**Description of Work**  
SFD/FINISH BASEMENT TO INCLUDE: RECREATION ROOM AND OFFICE BY FRAMING UP ONE (1) WALL TO SEPARATE AND REMODEL EXISTING FULL BATHROOM, APPROXIMATELY 1,300 SQ.FT.\*\*SMOKE DETECTORS REQUIRED

RESIDENTIAL RENOVATION for the  
 BASEMENT HOUSE LOCATED at  
 14500 Dorsey Mill Road  
 Glenwood, MD 21738

**From:** Oswald, Hank  
**Sent:** Wednesday, April 20, 2022 1:42 PM  
**To:** Armour Home Improvement Inc. (armourhomeimprovement@msn.com)  
**Subject:** B22001425\_14500 Dorsey Mill Road\_Finished Basement

**From:** Oswald, Hank  
**Sent:** Monday, April 25, 2022 11:30 AM  
**To:** Armour Home Improvement Inc.  
**Subject:** RE: B22001425 House Plans  
**Attachments:** P514694-A\_364902\_14500\_DORSEY\_MILL\_ROAD (1).pdf; Section 3.801 Bedroom Definition.pdf

**BASEMENT FLOOR PLAN**  
 SCALE: 3/16" = 1'-0"

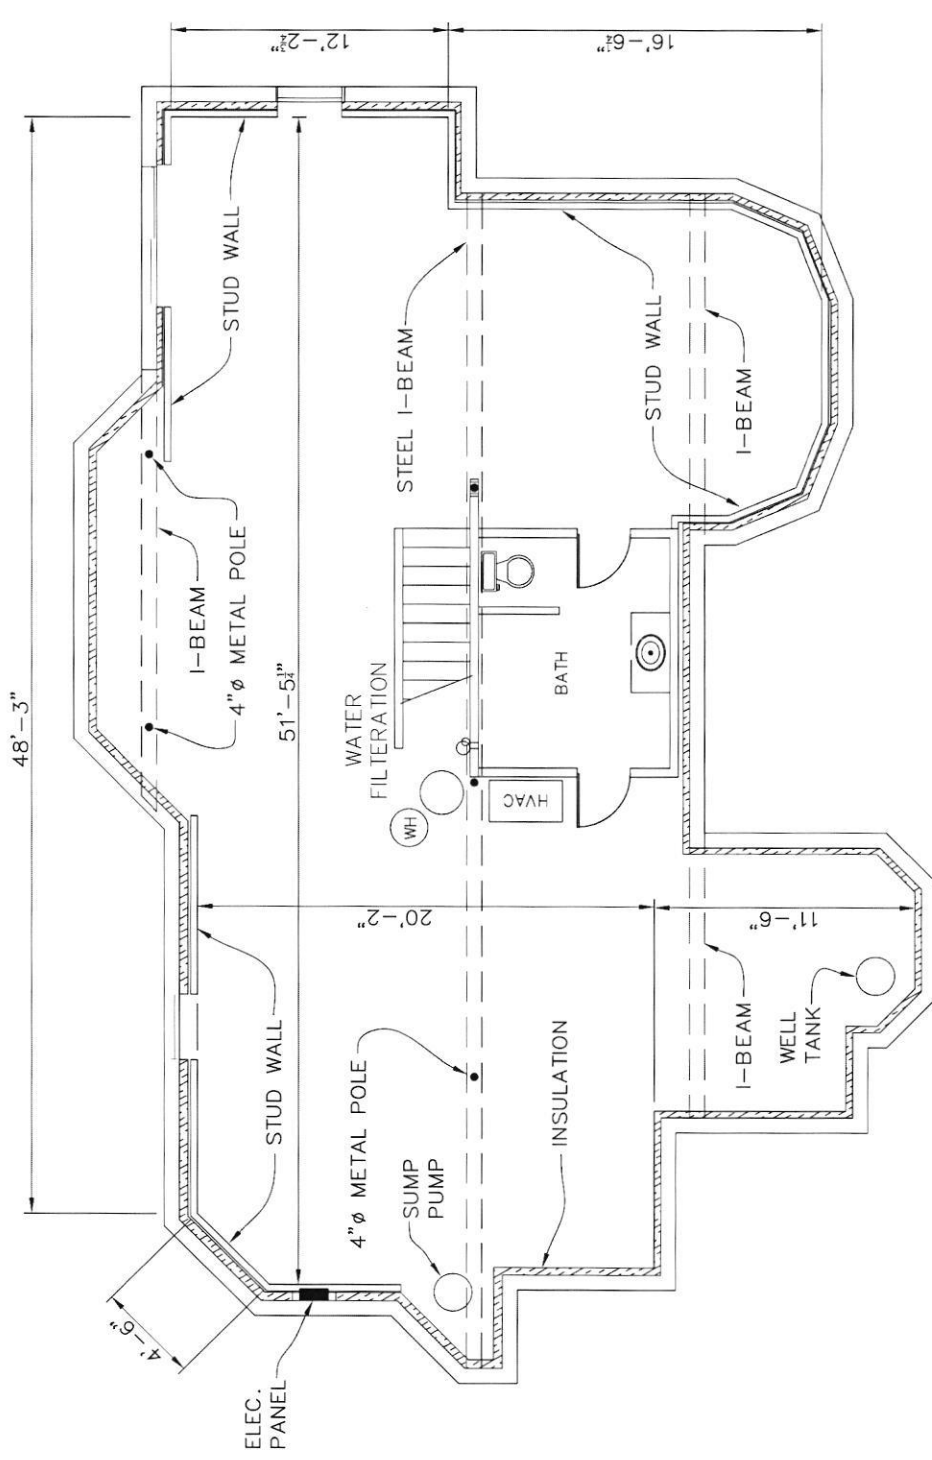
The existing floor plan shows 4 bedrooms (3 BR – 2<sup>nd</sup> fl. And 1 BR – 1<sup>st</sup> fl.). The proposed office in the basement also meets the definition of a bedroom (see attached definition).

The existing septic system is only sized for 3 bedrooms. Does the den on the 1<sup>st</sup> floor have permanent built in book cases around the perimeter of the room?

Trench Capacity = 210 linear feet x 3' wide = 630 sq. ft. divided by 0.71 for sidewall credit  $(3+2/3+1+2(1.5)) = 887 \times 0.8$  rate = 709 gallons per day allowed for that system (4.7 bedrooms).

You can either alter the floor plans to bring the bedroom count back down, or make upgrades to the existing septic system prior to building permit approval.

**BASEMENT FLOOR PLAN**

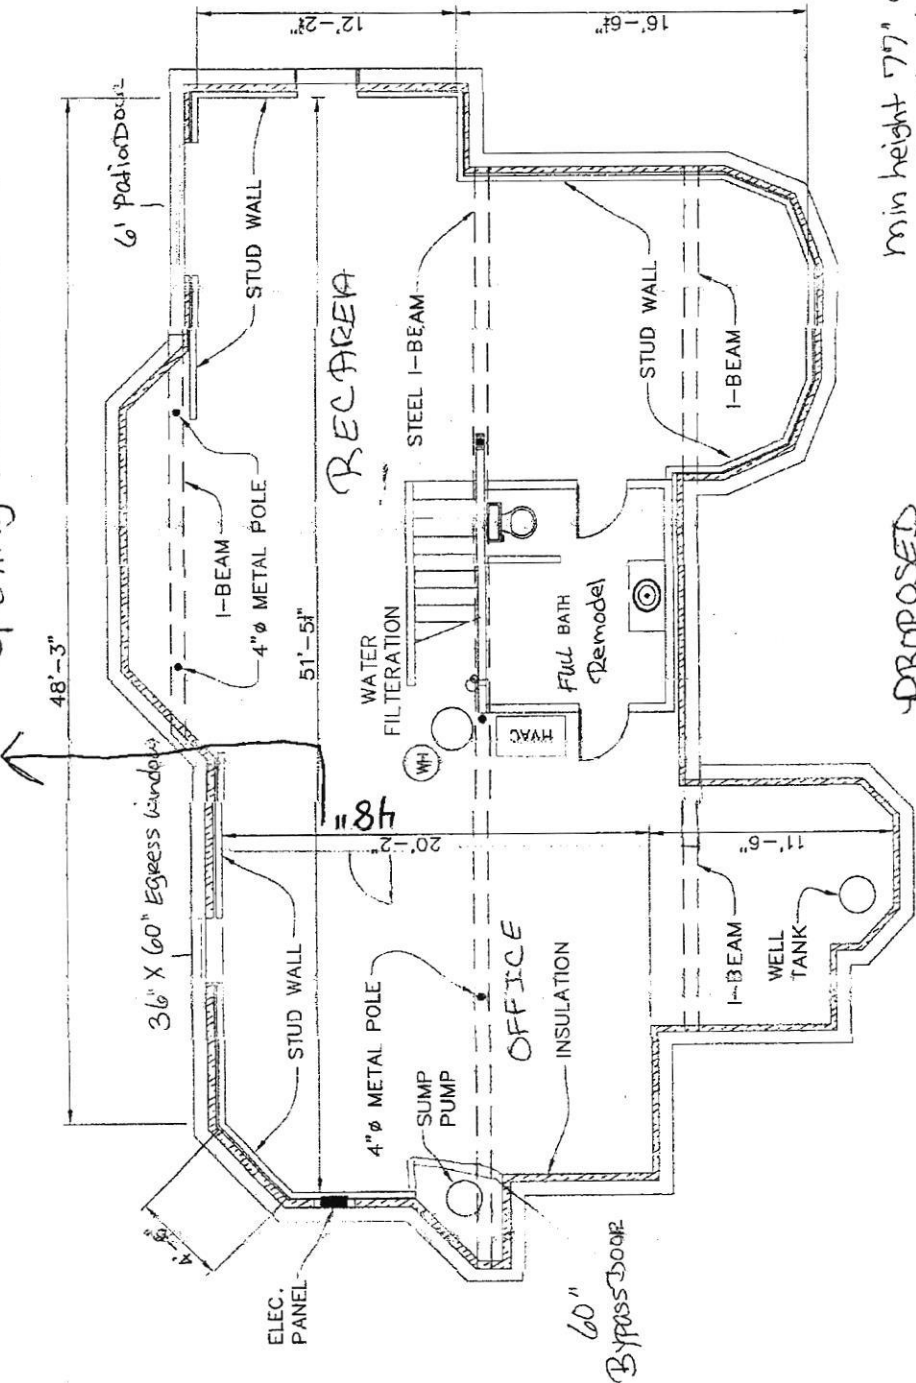
I did. It only reads "48 inches" on the floor plan. The floor plan should read something like "the opening into the "office" will be a 4 foot wide cased opening without a door".

Please see my email dated May 4<sup>th</sup> (below). There should be a written statement on the floor plan indicating the opening into the "office" will be a 4 foot wide cased opening without a door. Let me know when you've submitted the revision and I will look for it in the system.

The opening into the "office" will be a 4' wide cased opening without a door.

MAIN FLOOR PLAN  
SCALE: 1/8" = 1'-0"  
DATE: 11/11/11  
DRAWN BY: CA  
CHECKED BY: [blank]

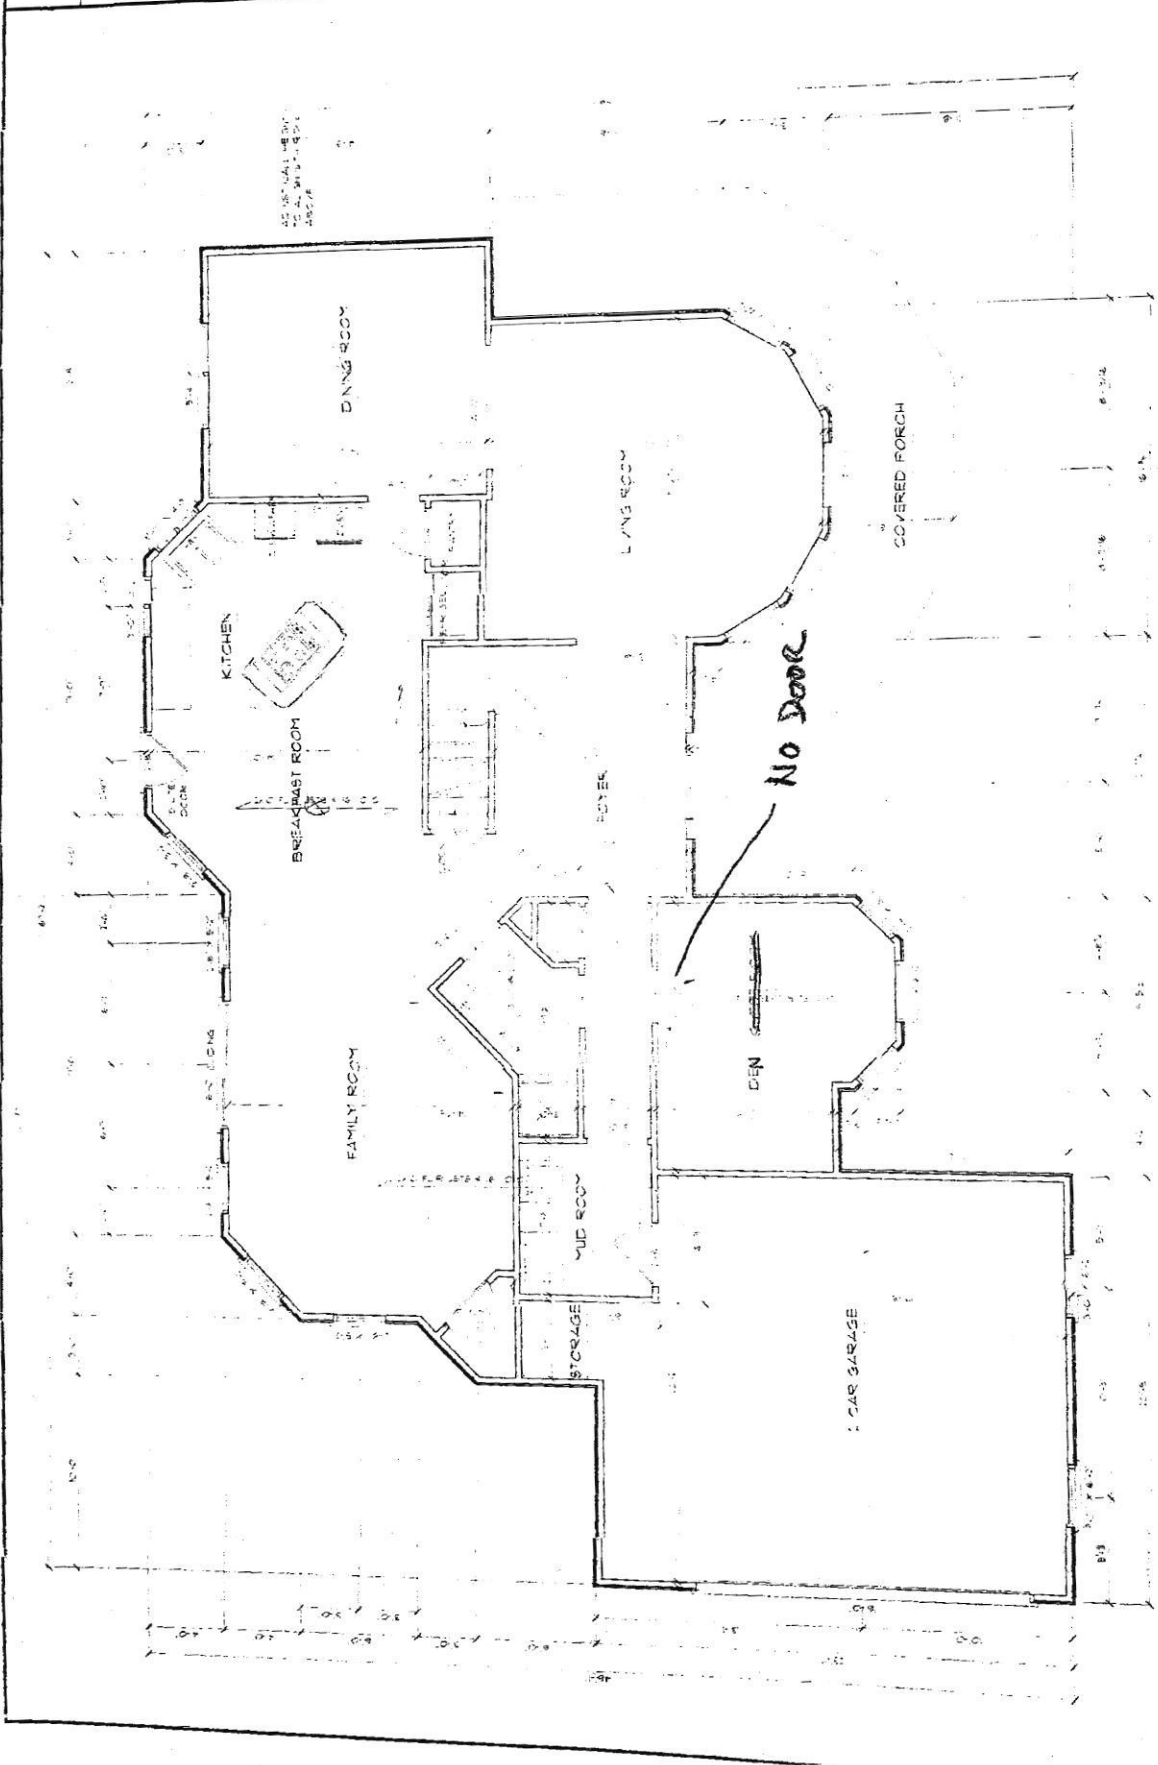
Are you proposing to alter the entrance into the "Den" on the first floor to reduce bedroom count? If yes, you'll need to indicate it on the floor plan and submit it to permits office. The entrance must be labeled "4 foot wide cased opening without a door". In addition, the same goes for the proposed room in the basement unless you are choosing one of the

The existing septic system is only sized for 3 bedrooms. Does the den on the 1<sup>st</sup> floor have permanent built in book cases around the perimeter of the room?

Thank you for speaking with me. Please find attached the 1<sup>st</sup> level floor plan altered showing the existing Den and no door for approval. This PDF is poor quality so hopefully you can make out what is necessary. Please let me know if you need anything further. Thank you for your assistance in this matter.

Thank you for your email and attachments. The first level Den is truly a Den. It has never been used as a Bedroom. It has bookshelves. No closet and no doors.
